# WATER QUALITY MEMORANDUM

## Utah Coal Regulatory Program

RE: Third Quarter 2015 Water Monitoring, Alton Coal Development LLC, Coal Hollow, C/025/0005, Task ID #4990

Figure 1. Well Y-102: Alluvial well in upper Sink Valley to the east of pit 9 in permit area.

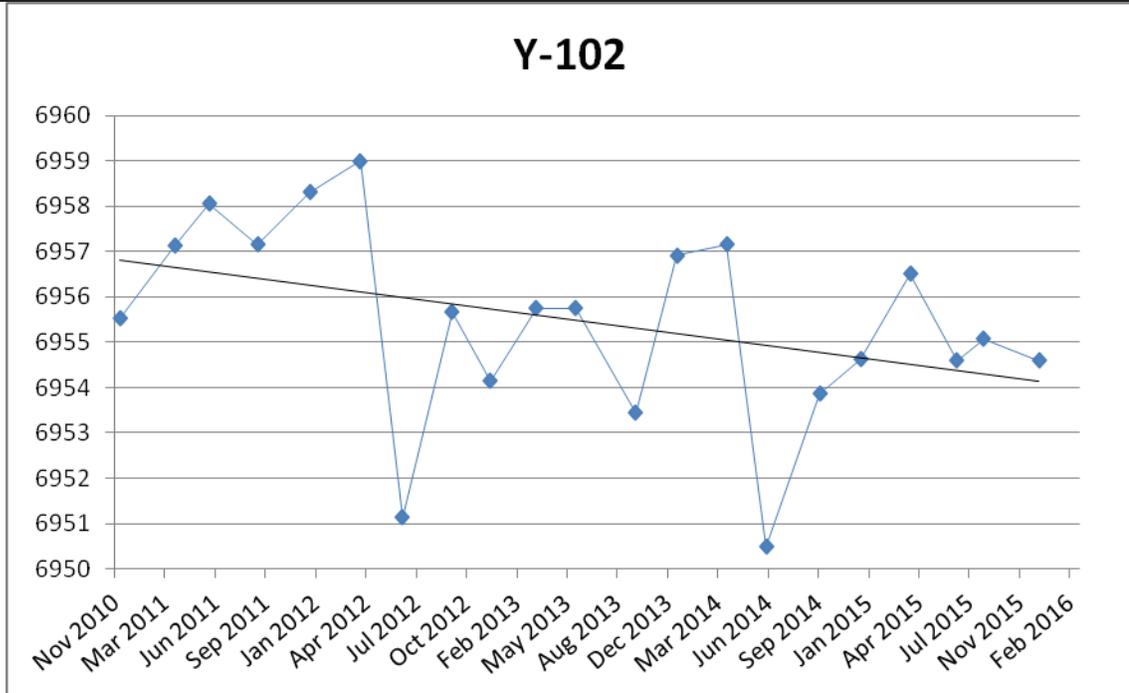
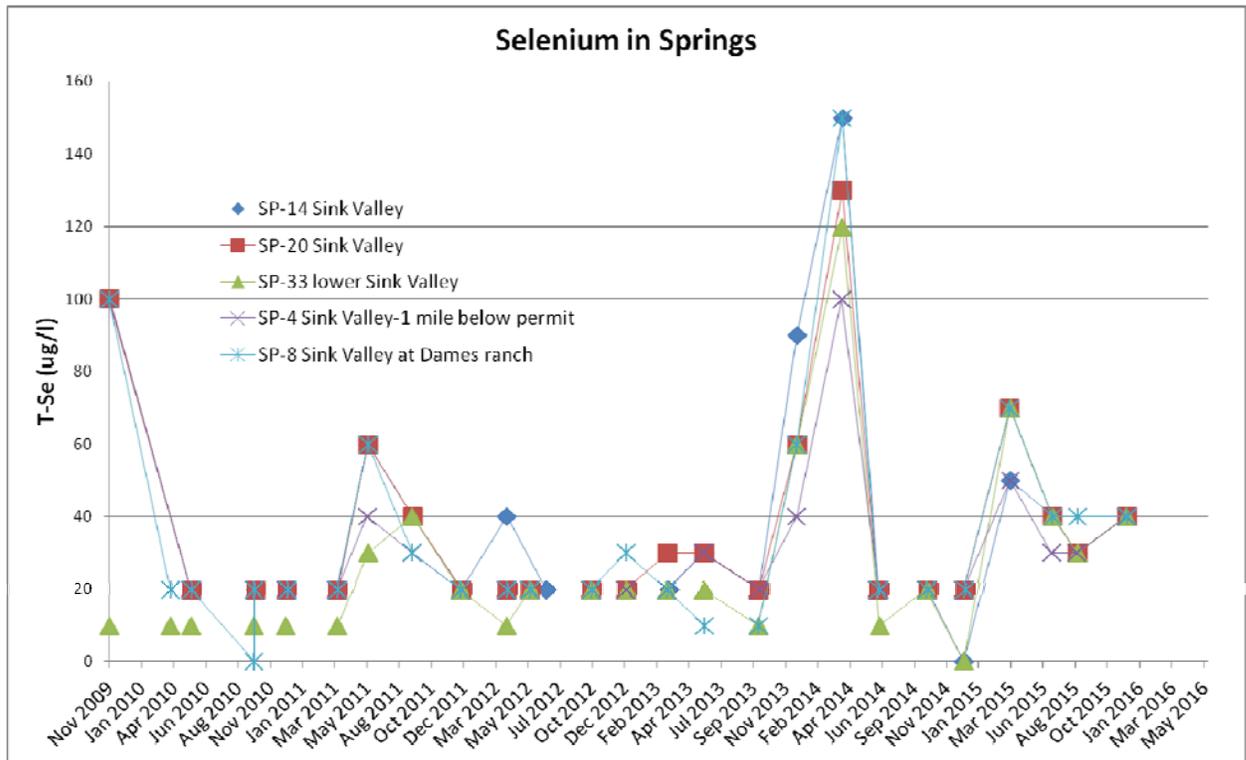
Well 102 is dropping. These levels are dropping because the mine's production well is pumping just up-gradient (Figure 1).

None, however tracking the water elevation in well Y-102 would be worth continued examination. Monitor down gradient wells in Sink Valley and the C-series wells. Continue to monitor elevated selenium in springs, streams, and wells.

Figure 2. Elevated Selenium levels at Spring, Stream, and Well locations through Q4 2015. 20 ug/l and below on the y-axis is the ND limit for measuring Selenium.

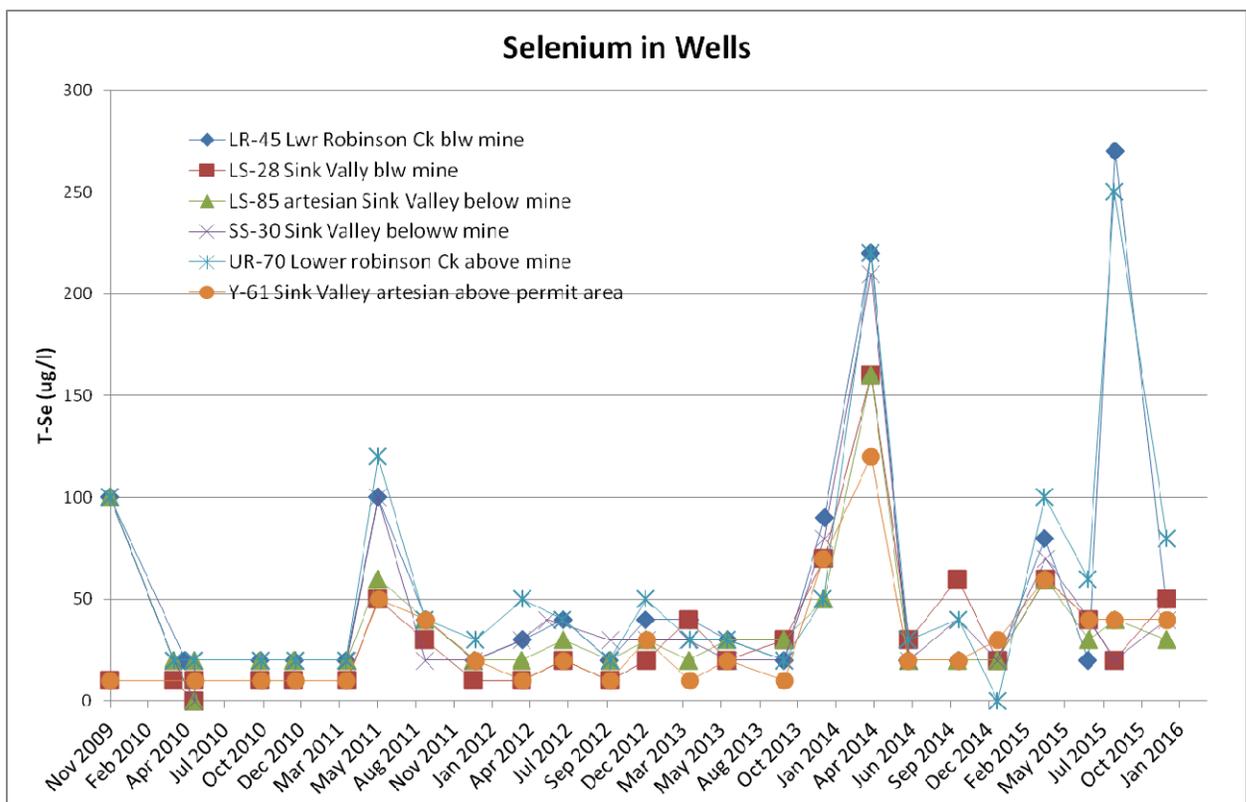
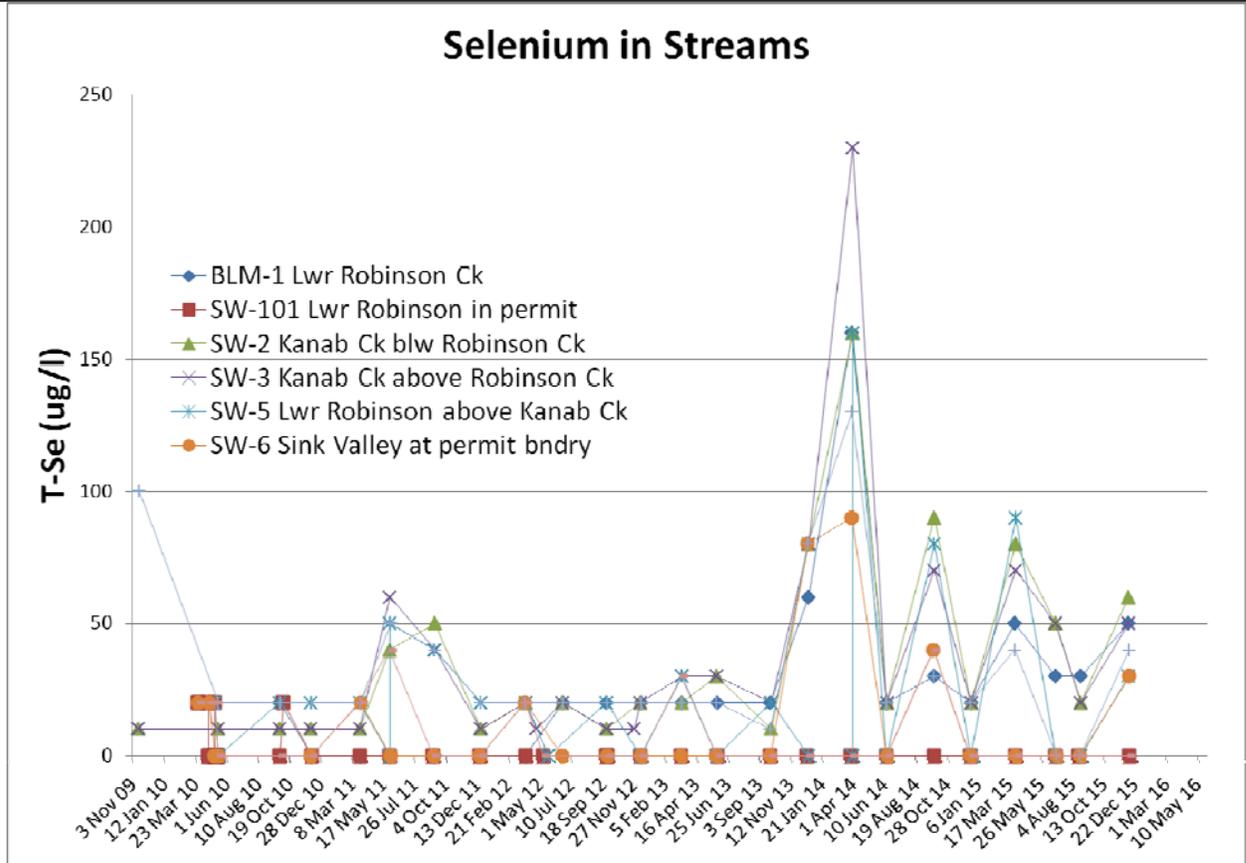
Selenium levels in Kanab Creek may be listed by DWQ as a non-point source pollutant. There have been significant spikes in T-Se in the past few years (see Figure 2). When Chemtech-Ford has a difficult time processing Selenium they show the value as <100, which I ignore.

There have been significant spikes in T-Se levels early in the year that have since gone down.
